modified numeration table		31-10-06			
		added part 291.1		17-10-06			
ref.		note		date		signature	
modifications							
296	4	AISI 316	1/1				
295	8	Fe 360	1/1				
294.1	8	carbon steel	1/1				
294	4	AISI 316	1/1				
ref.	pieces	mat. and treatments	scale	ref.	pieces	mat. and treatments	scale

General machining tolerances UNI 5307-63								
Dimensions	< 6	> 6-30	> 30-120	> 120-315	> 315-1000	> 1000-2000	> 2000-4000	> 4000
linear Toll.	± 0.1	± 0.2	± 0.3	± 0.5	± 0.8	± 1.2	± 2	± 3
angular Toll.	± 1'	± 30'	± 20'	± 10'				referred to the shortest side
designed for				R.De Salvo				
LIGO PROJECT				draw. by G.Gennaro-PROMECC				
date				16-10-06		scale		1/1
title				HAM OPTICAL BENCH				
ELEVATOR				LIGO-D051251-02-D		detail from		194 A 2

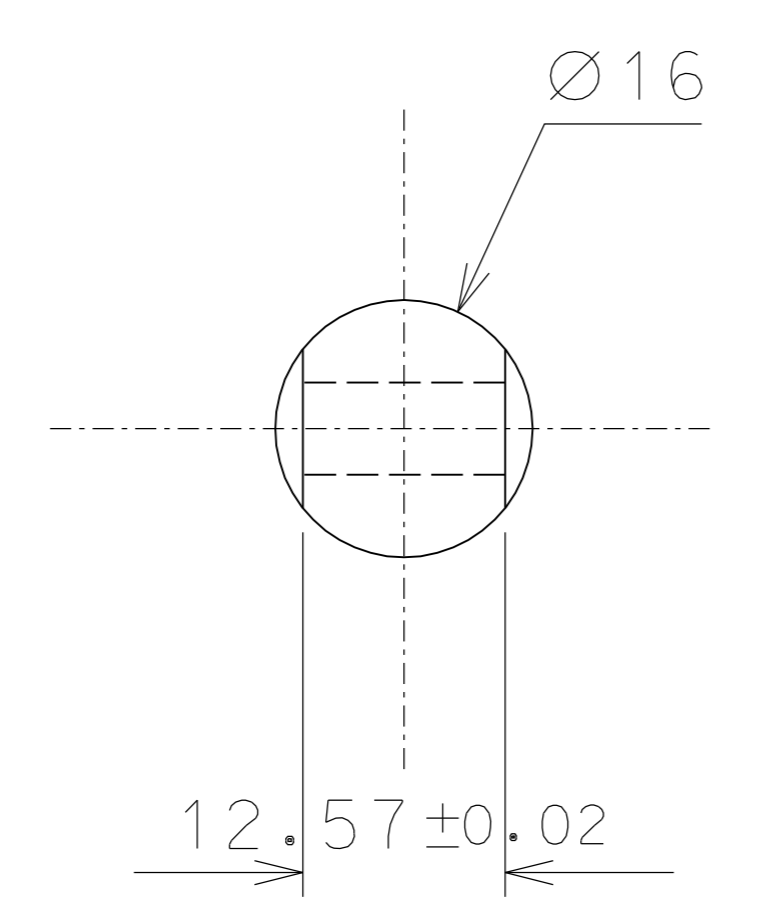
Nichel flashing

use stainless steel M16 bolt

use M12 bolt

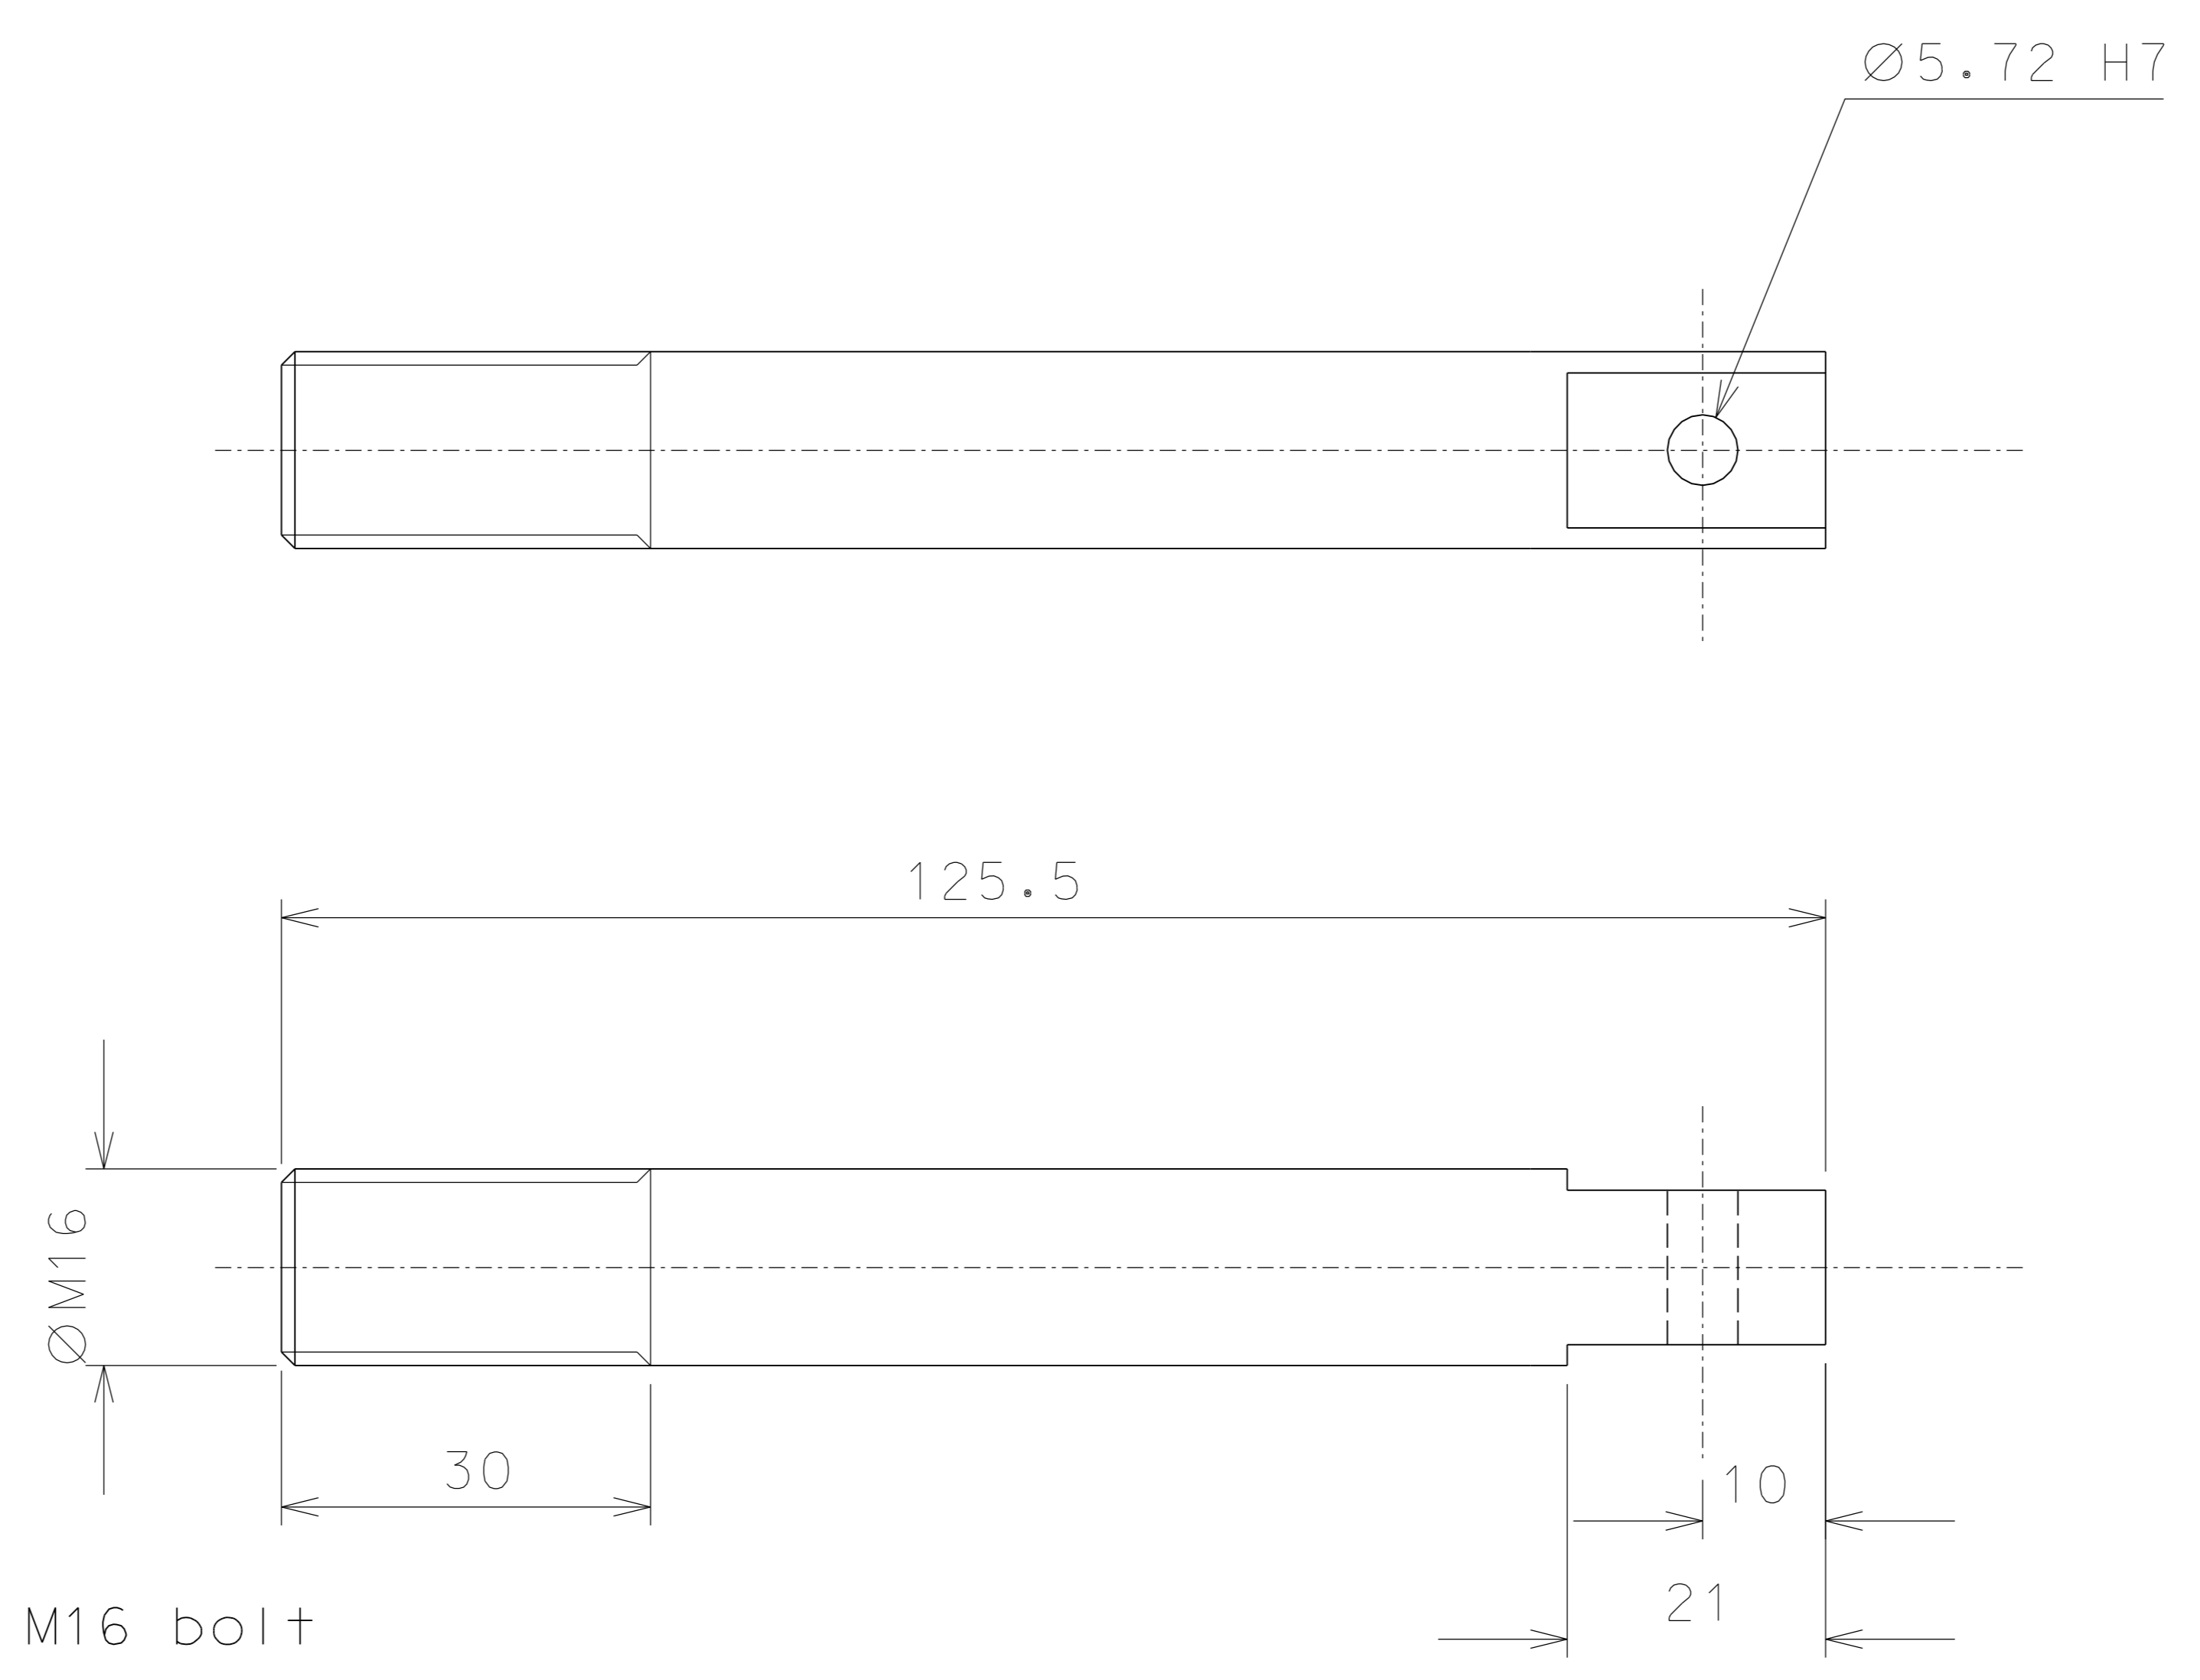
use stainless steel M16 bolt
